INFINIX MOBILITY LIMITED

Subject: FCC Class II Permission change for FCC ID: 2AIZN-X6858
Original Grant Date: 12/29/2024

This is to request a Class II permission change to our Mobile Phone; Model: X6858, FCC ID: 2AIZN-X6858, the device is identical to the previously certified except for the changes as below for details:

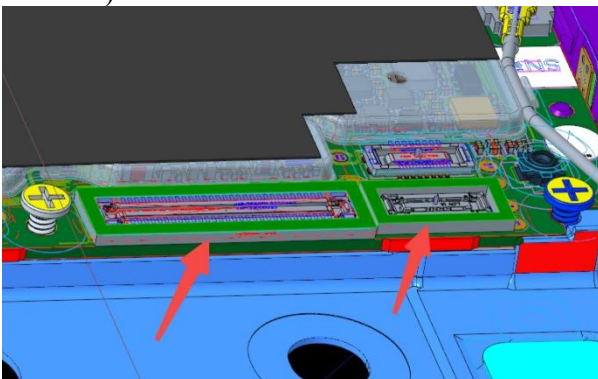
1. WPT Antenna: Enlarged appearance (The FPC is lengthened by 1.8mm, the coil remains unchanged, and the wireless coil charging power is not affected);
2. LED FPC, Reduced appearance (The FPC is shortened by 3.7mm and the width is increased by 1mm. The appearance is changed but the function is not affected.)

3. The device is adds two silicone rings as shown below (does not affect the function)
